APPENDIX B

Summary of DRA Analysis of Late-Filed ALJ Exhibits

A. Estimation of hydrotest costs used to calculate disallowances for pipe replacement projects

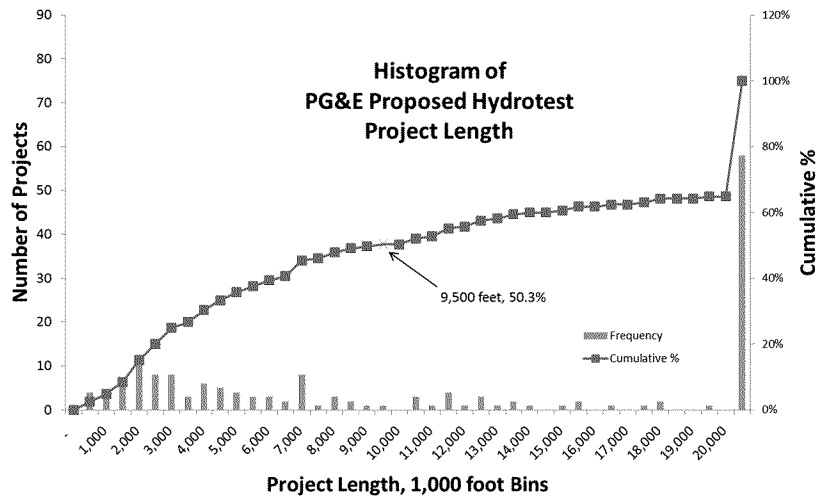
In addition, the record shows that hydrotest costs per foot decrease with increased length of a project, as fixed costs are spread over a larger length of pipe. The following chart shows hydrotest costs per foot for PG&E’s 165 proposed hydrotests projects, as a function of the length of each project:

This chart shows that short test projects, including all those shorter than 10,000 feet, have a cost per foot higher than \$95.8.

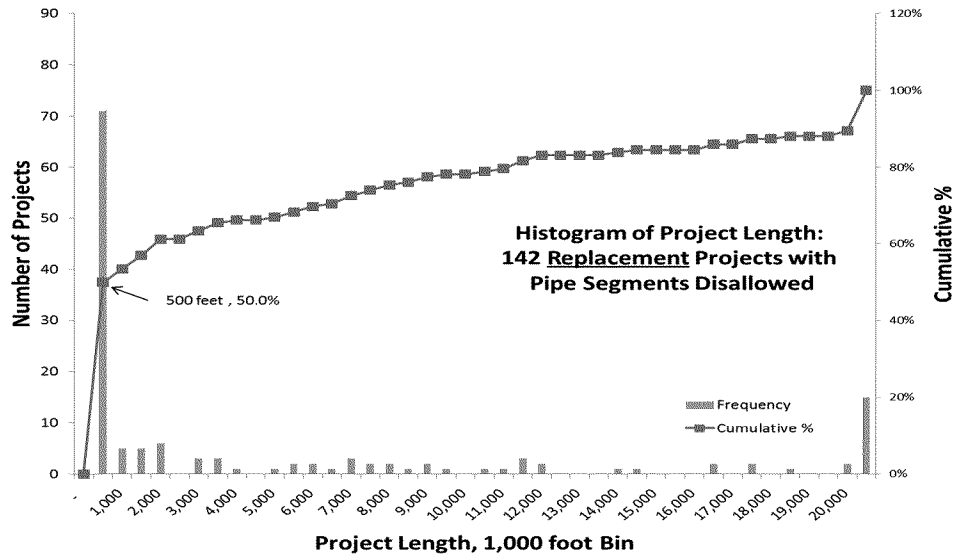
In comparison, the median length of PG&E's proposed replacement projects is 509 feet, over 17 times less than the median length of hydrotest projects:¹²

This chart shows that the majority of proposed *replacement* tests (84 of 168) are less than 1,000 feet long.

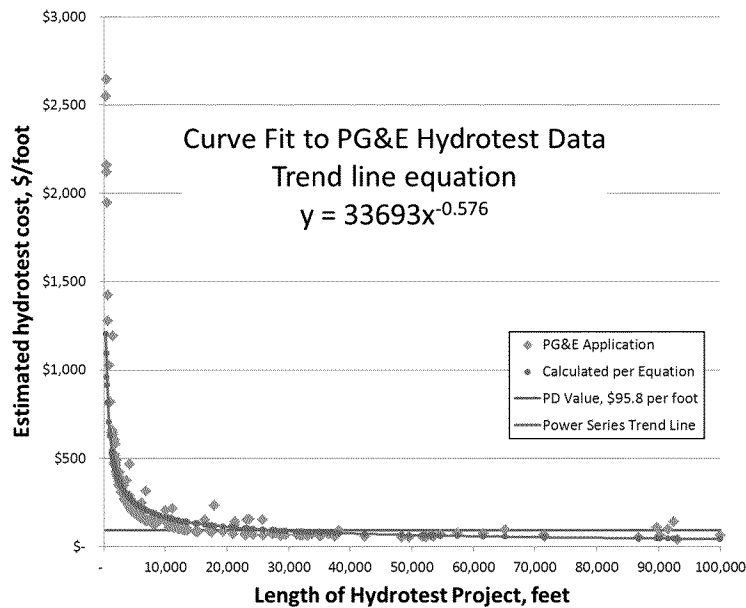
Not all replacement projects have segments that are disallowed, regardless of whether PG&E or DRA’s cost allocation criteria are used. DRA therefore performed a similar analysis on the 142 replacement projects with disallowances using the criteria of Scenario 3 as described in Section II.A.2(a) of DRA’s Comments on the PD.¹³ The median value of these projects, 512 feet, and the frequency distribution are similar to the full set of replacement projects:¹⁴

This data shows that PG&E pipe *replacement* projects are much shorter than *hydrotest* projects, and that the single estimated hydrotest cost of \$95.8 per foot is inappropriately low for use for replacement projects, the majority of which have short pipe lengths.
